1. PCI Standard Hot-plug Engineering Change Notice – SHPC Extensions for PCI-X 2.0

TITLE:	SHPC Extensions for PCI-X 2.0
DATE:	February 27, 2003
AFFECTED DOCUMENT(S):	PCI Standard Hot-Plug Controller and Subsystem Specification, Revision 1.0
SPONSOR:	Alan Goodrum, Hewlett-Packard, and Sridhar Muthrasanallur, Intel

Figure 4-20: Slot Status Field

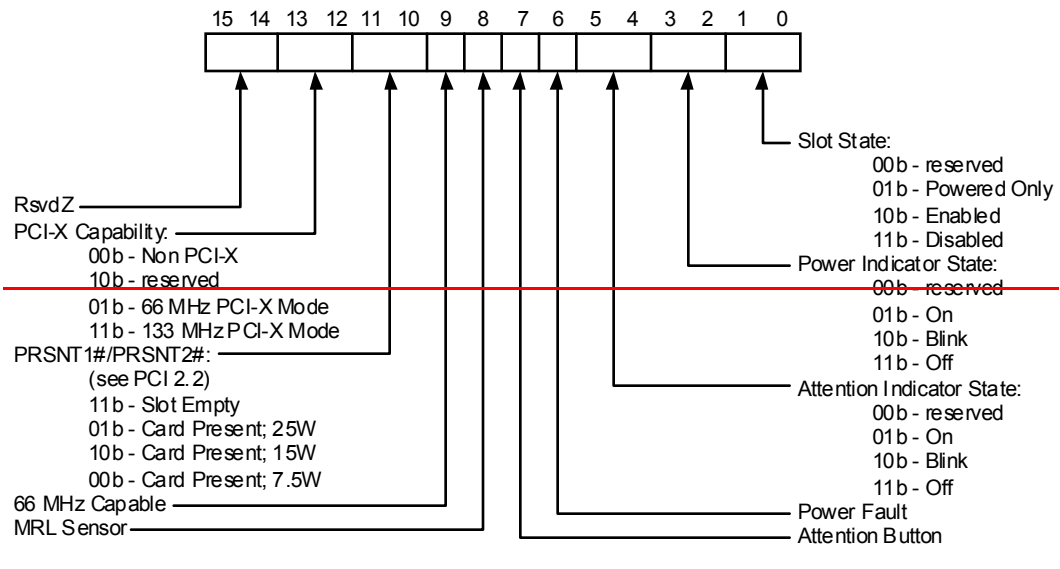
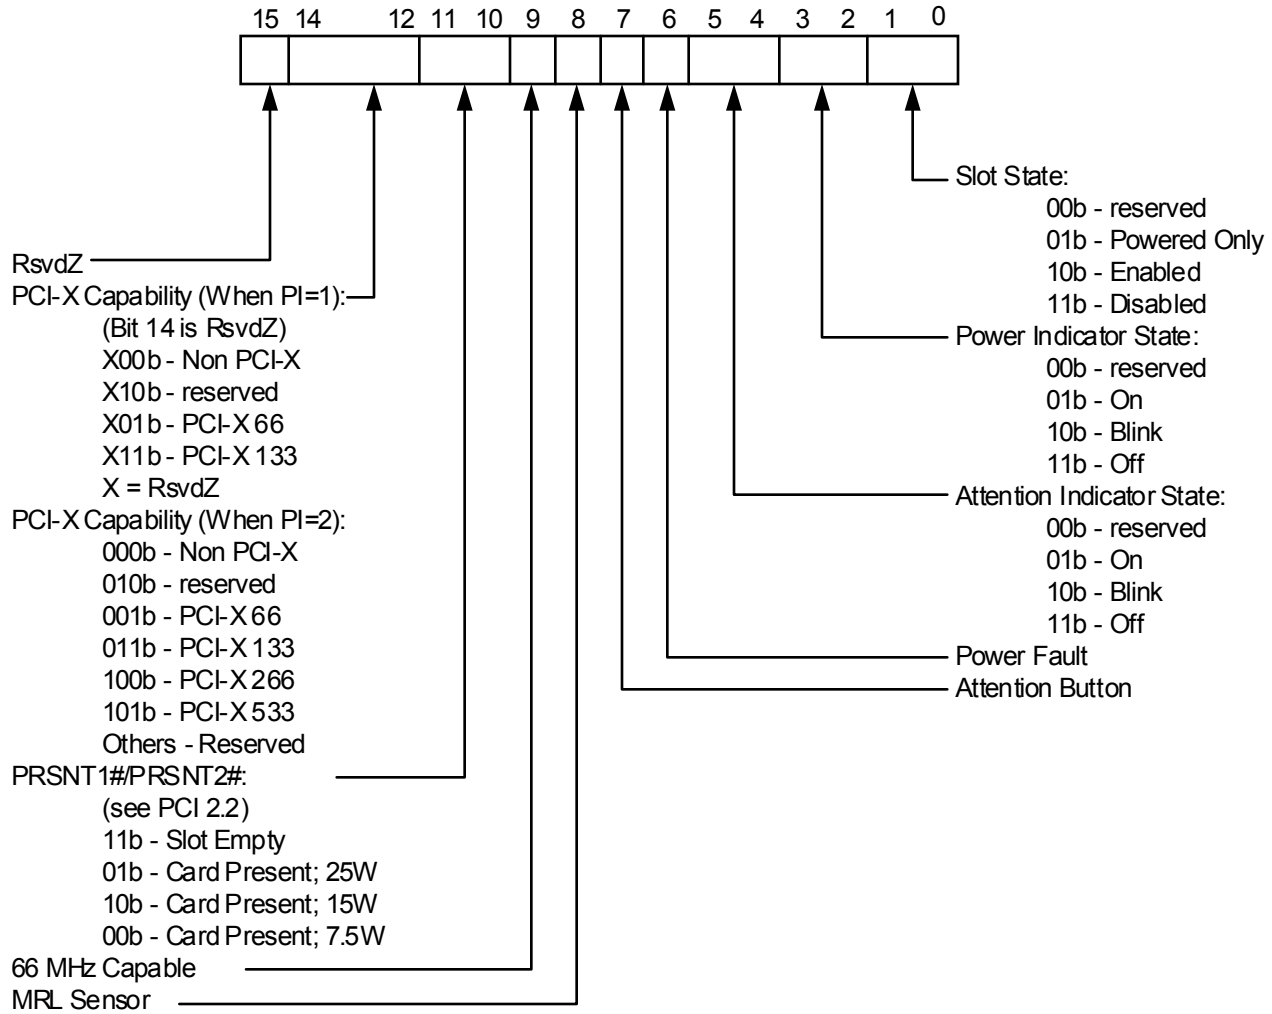
Change Instruction: Change Section 4.5.12.1 pg 124, as follows:

13:12	<p>PCI-X Capability – These bits report the current PCI-X capability of the add-in card installed in the slot (see Figure 4-20). These bits are not valid if the slot is empty. If the slot is occupied, these bits are valid regardless of the state of the slot or speed/mode of the bus.</p>	RO
<u>When PI=2</u>		
<u>14:12</u>	<p><u>PCI-X Capability – These bits report the current PCI-X capability of the add-in card installed in the slot (see Figure 4-20). These bits are not valid if the slot is empty. If the slot is occupied, these bits are valid regardless of the state of the slot or speed/mode of the bus.</u></p>	<u>RO</u>
